STATEMENT OF RESPONSE TO AN BORD PLEANÁLA'S CONSULTATION OPINION

IN RESPECT OF A
**PROPOSED RESIDENTIAL DEVELOPMENT AT
COOKSTOWN, ENNISKERRY, CO. WICKLOW**

Client:	Cairn Homes Properties Ltd.
Project Title:	Cookstown Enniskerry SHD
Document Title:	Statement of Response to An Bord Pleanála’s Consultation Opinion
Document No:	19144SRABPF01

Figure 2.1 – Cookstown Road Upgraded Pedestrian Link and Lighting

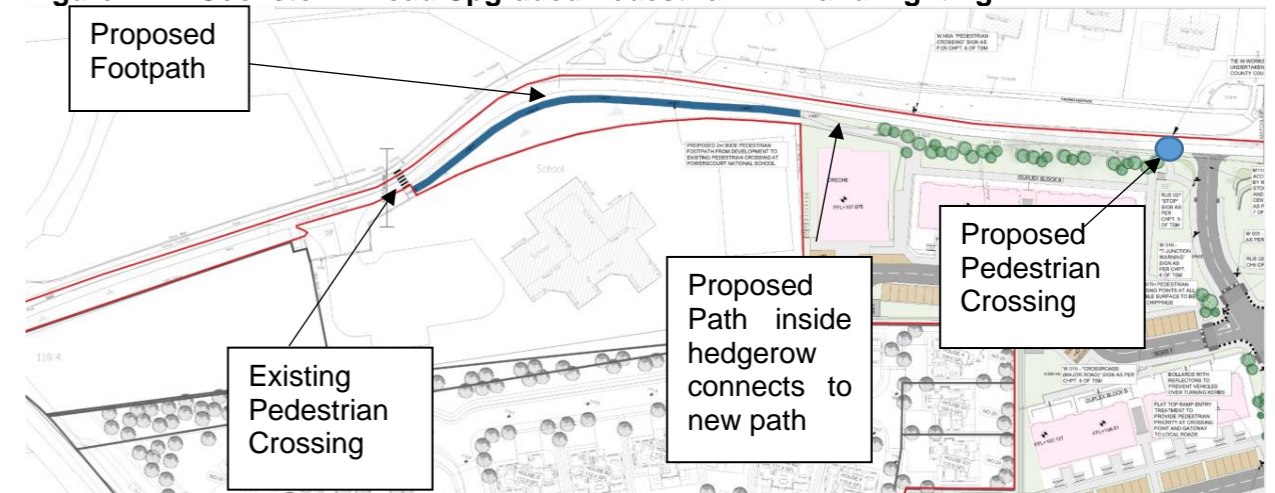
“Further consideration of movement (pedestrian, cyclist and vehicular) within and through the development site, and to Enniskerry, and in particular the need for additional/upgraded pedestrian links, and how pedestrian movements will be facilitated in a safe manner across the Cookstown Road, as well as the potential need for road widening to facilitate the development.

2.5 A lighting plan, prepared by Sabre is included with the SHD application. The potential for road widening was considered by the design team and the preference was to keep the trees/hedgerow as much as possible along the Cookstown Road, and include a pedestrian footpath on the development side of the Hedgerow/tree boundary which will link into a new footpath on the southern side of the Cookstown Road.

In addition, with the agreement of Wicklow County Council, a pedestrian crossing is to be provided to tie into the existing footpath located on the northern side of the Cookstown Road (see figure 2.5).

Figure 2.6 – An Bord Pleanála Pre-application Request Arrangement

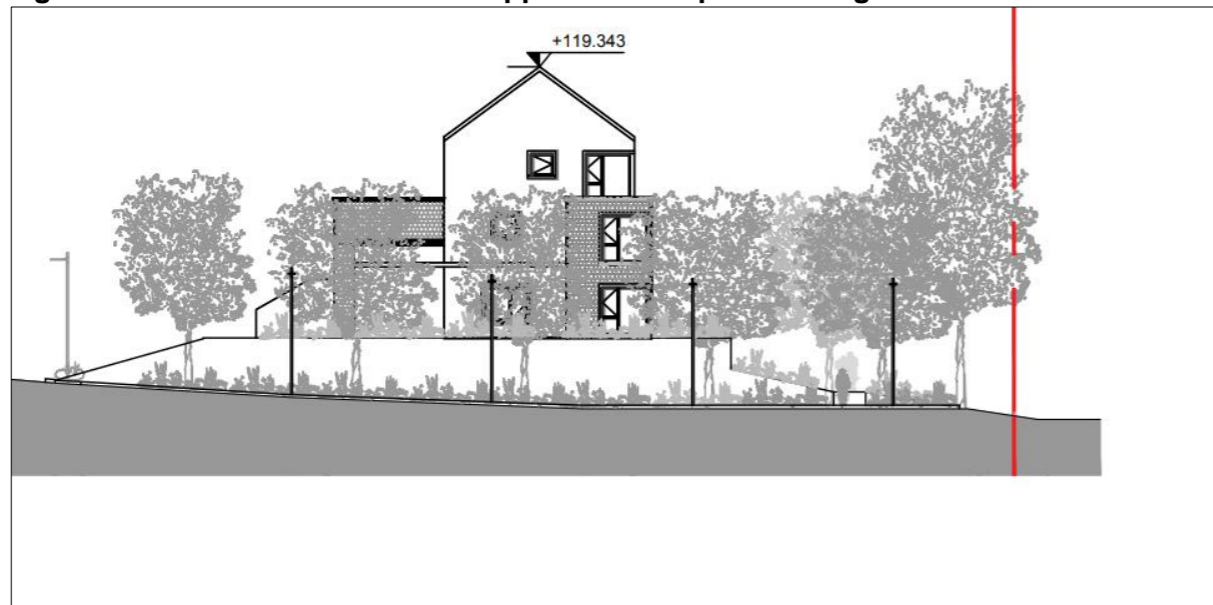
“The prospective applicant should provide further justification and/or detail in relation to the proposed interface with the Cookstown Road, having regard to the apparent level differences from the road to the site, and the potential need for retaining walls. The applicant should provide detailed elevations/cross-sections/photomontages and CGI’s showing this interface. Further consideration of this issue may require an amendment to the documents and/or design proposals submitted.”

2.36 In response to this item, the arrangement and architectural design along the Cookstown Road has been reviewed. The key elements include the redesign of the interface in the north western corner to include a reduction in levels, redesign of the creche and redesign of the duplex building and arrangement in the north western corner of the site.

Figure 3.2 – Proposed Eastern Boundary Arrangement

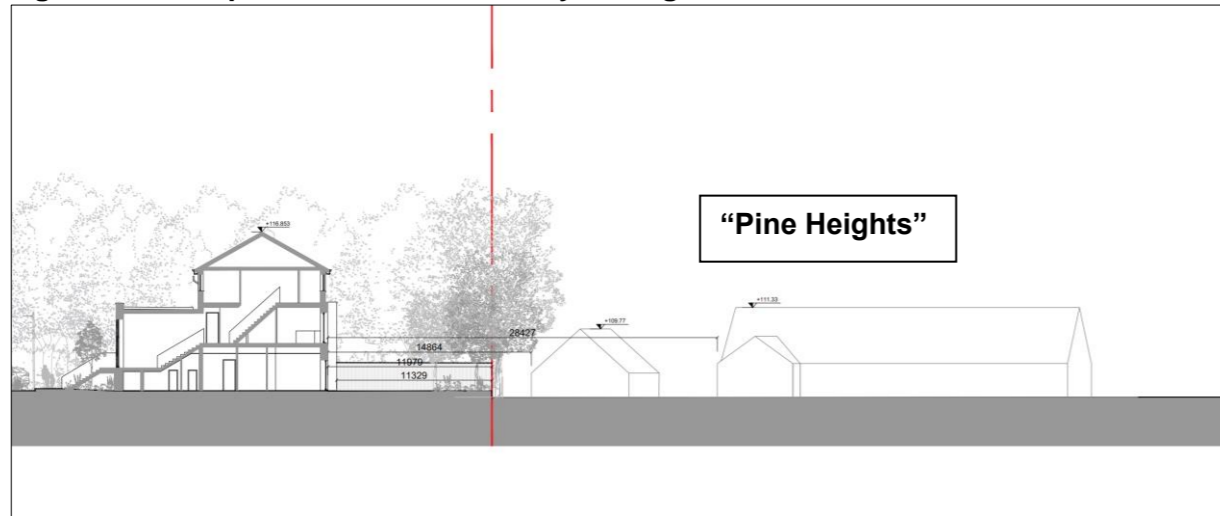
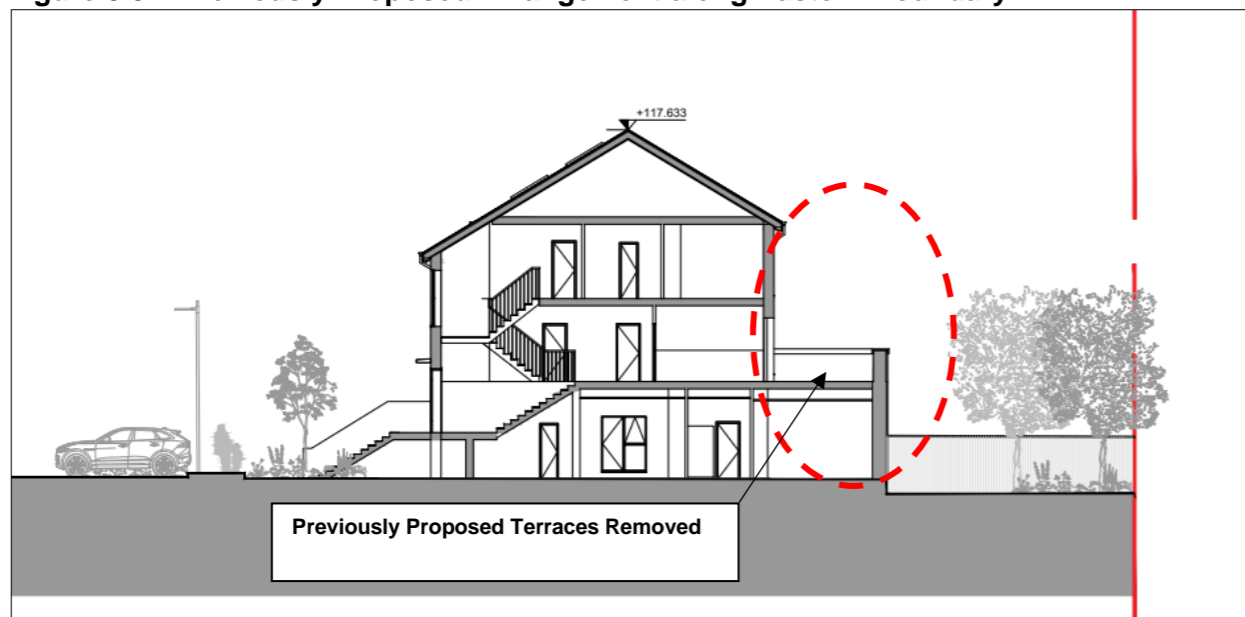
“2 A report that addresses issues of residential amenity (both existing residents of nearby development and future occupants), specifically with regards to daylight/sunlight analysis, overlooking, overshadowing, overbearing and noise. The report shall include full and complete drawings including levels and cross- sections showing the relationship between the proposed development and nearby residential development.”

3.12 In relation to overlooking/overbearing, the arrangement of the proposal was amended to so that the terraces previously proposed along the eastern boundary were relocated internally so as to avoid the perception of overlooking along that boundary. The revisions to the layout results in an appropriate transition between the proposed scheme and the existing 2 no. dwellings located to the east.

3.13 The following shows a cross section arrangement at a point along the eastern boundary (adjacent to 'Pine Heights'. It can be seen that the distance from the rear façade of the duplex building is c. 28.4m to the adjoining residence. Furthermore it is noted that the proposed windows are c. 11.9m from the boundary and that the existing planting along the boundary will remain.

3.14 With regard to the dwelling to the south (of Pine Heights) it is noted 'Tinnabeg' is located c. 29.3m from the boundary to the proposed development and c. 11 m from the proposed duplex buildings. The previous arrangement proposed at Pre-application stage is outlined below which shows the previously proposed terraces at first floor level.

Figure 3.10 – Materials Palette

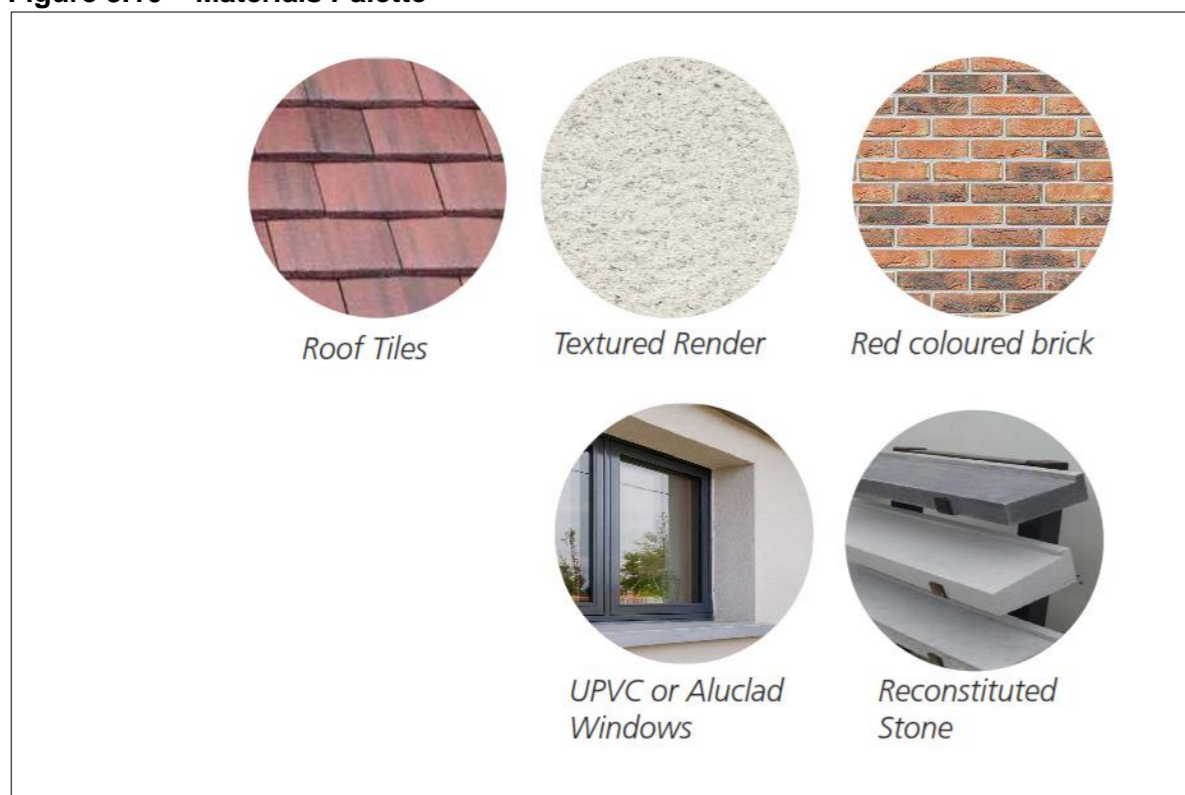
“4. A report that specifically addresses the proposed materials and finishes of buildings, landscaped areas and any screening/boundary treatment. Particular regard should be had to the requirement to provide high quality and sustainable finishes and details which seek to create a distinct character for the development.”

3.49 The response to this item combines the materials detail from the SHD application and comprises the Materials Report. We refer the Board to the Architectural Design Statement prepared by MOLA which includes detail on the proposed high quality materials and finishes, which provide a distinct character for the proposed development. All house and duplex units, as well as the creche, share a similar architectural language which will bring coherence to the development.

Figure 3.12 – Private, Communal, and Public Space

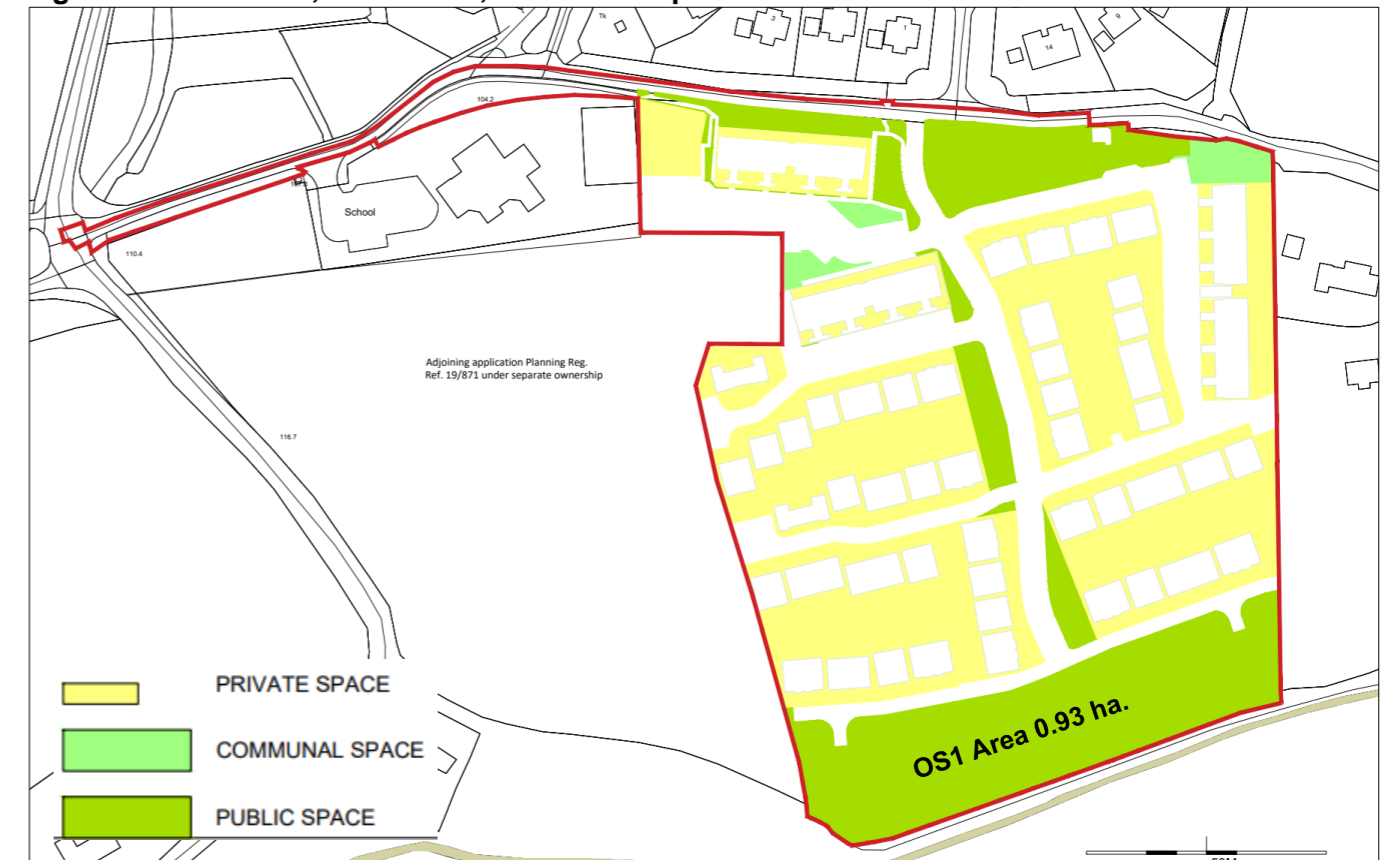
- 3.63 Item no. 5 seeks:
“5. A plan of the proposed open space within the site clearly delineating public, communal and private spaces.”
- 3.64 We refer the Board to drawing no. 19010_MOLA_A00_00_DR_A_XX_A00_0820, “Private, Communal, and Public Space, prepared by MOLA Architects (see extract below).
- 3.65 The proposed development includes a substantial linear park open space area (zoned OS1) along the southern boundary of the subject site of c. 0.93 hectares. In addition to this on the residential zoned area of 5.16 hectares, some 0.4 ha of open space is provided (7.7%), which is above the 7.5% minimum requirement. Combined the two areas amount to 1.33 hectares of the gross site area or c. 21.2% of the overall site area.
